Origination Form

Proposed Revisions to a Standard Plans Index

Originator:	Turley, Joshua	Index Number:	102-201
Date:	6/27/2024	Sheet Number(s):	2
E-mail:	Joshua.Turley@dot.state.fl.us	Index Title:	TEMPORARY ACROW SERIES 700XS DETOUR BRIDGE BEAM AND GUARDRAIL DETAIL

THRIE BEAM TO BRIDGE GUARDRAIL TRANSITION

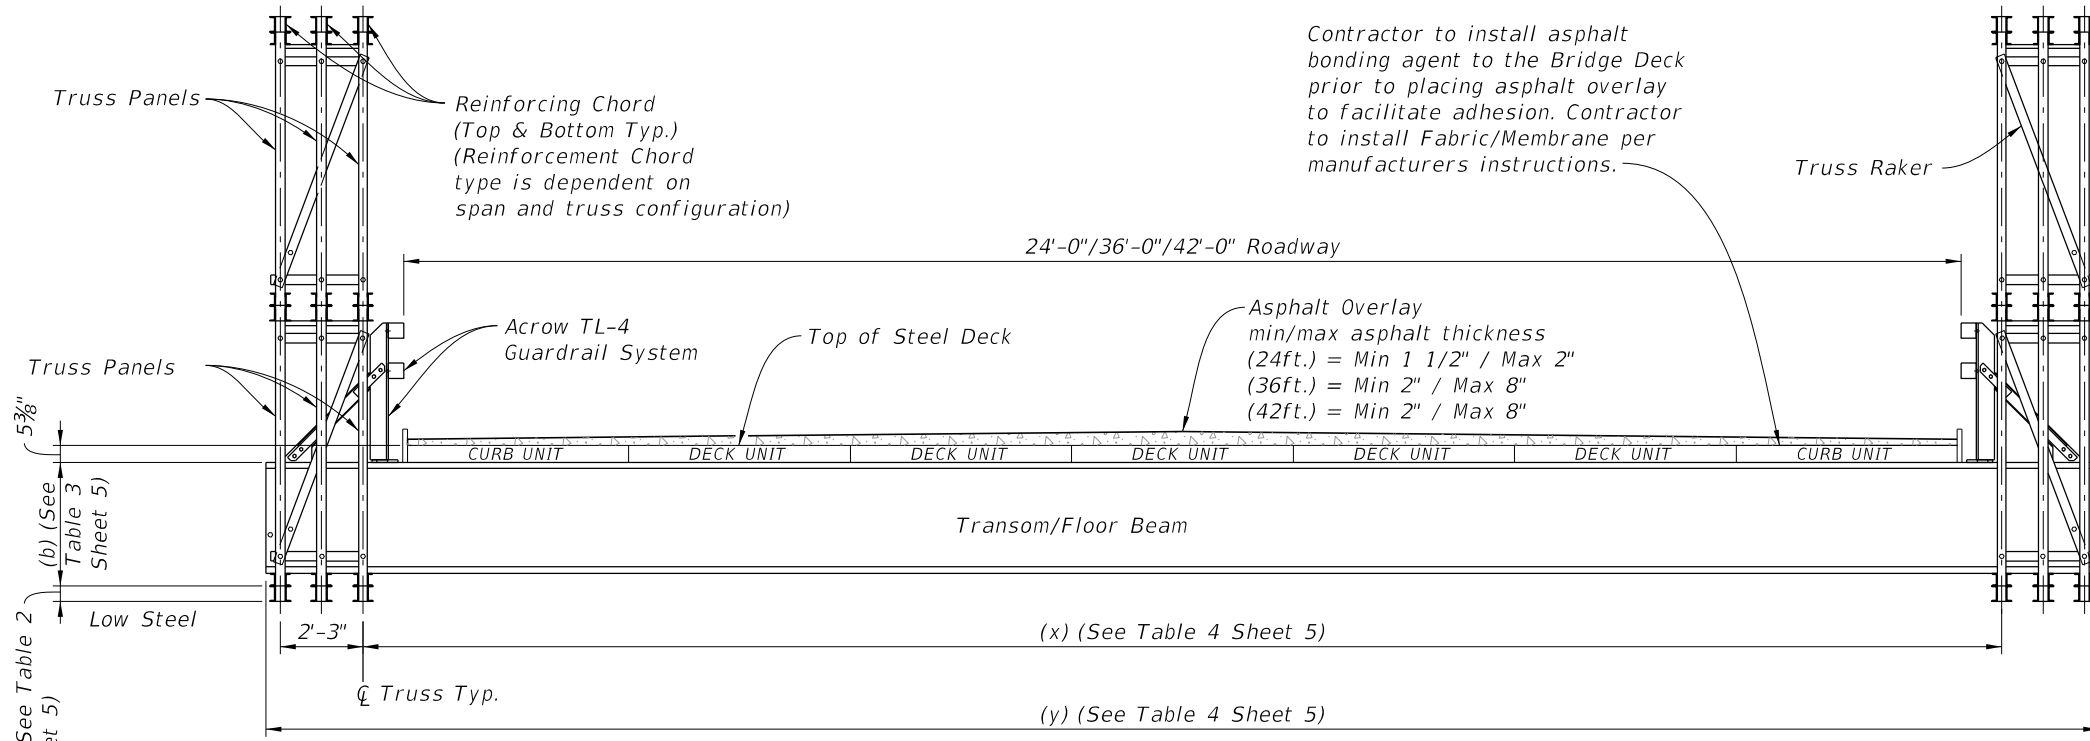
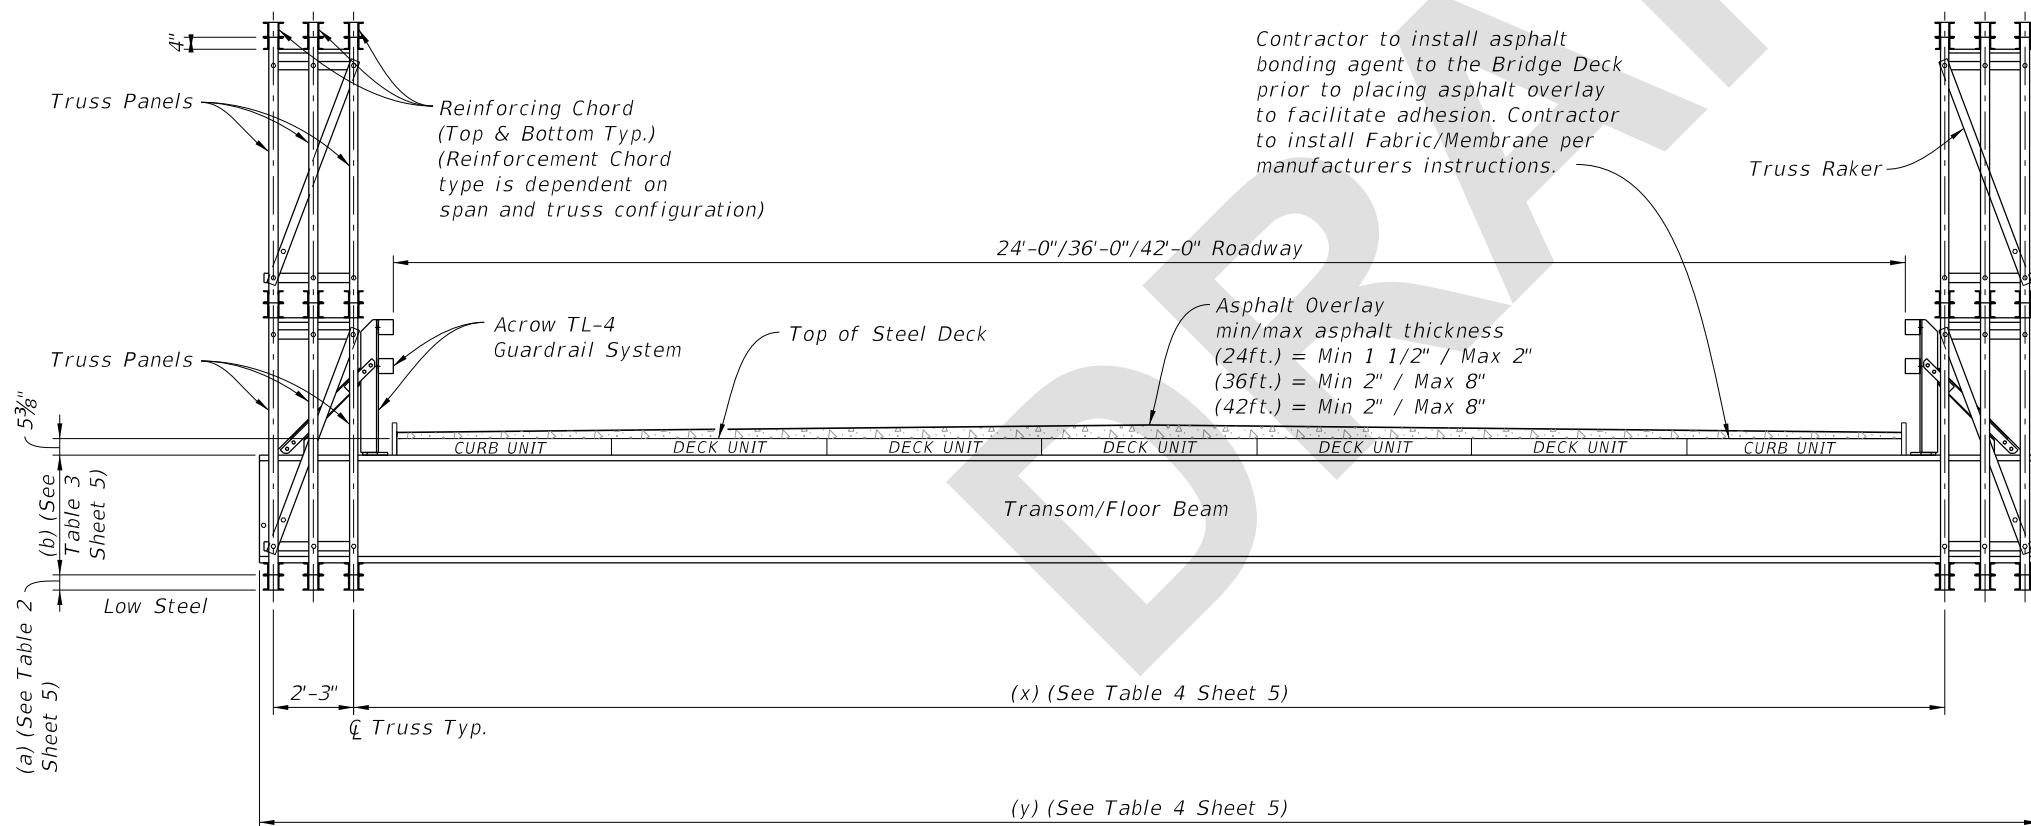
Sheet 2: Added Paved Surface to Thrie Beam to Bridge Guardrail Transition detail and updated dimensions to accommodate; Added additional callouts to Guardrail End Transition detail; Lengthened the plate size in the 1/4" Guardrail Back Plate Detail, clarified the dimensions and added notes

UPDATED dimensions and detail to accommodate paved surface

1/4" GUARDRAIL BACK PLATE DETAIL

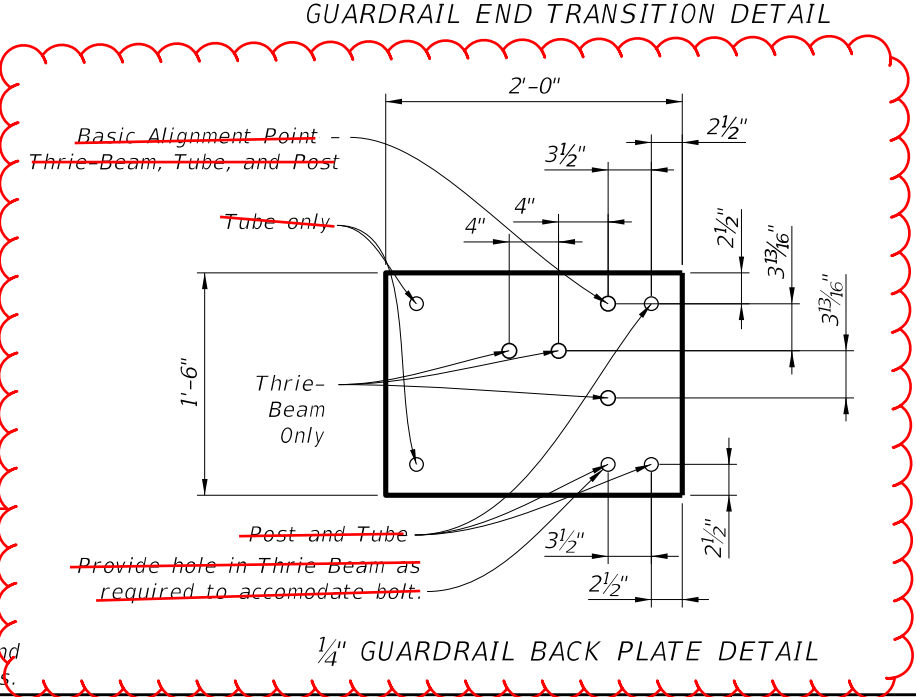
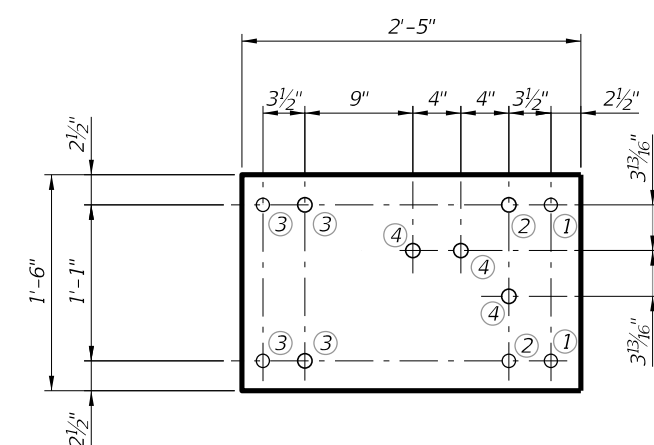
Lengthened plate size for better alignment and added notes for clarity

Back Plate is ASTM A36.
Use plate washers for all Thrie-Beam to plate connections.
Use 7/8" Ø Hex Head Bolts.
Drill, ream, or slot holes in Thrie-Beam connector as required for fit up.
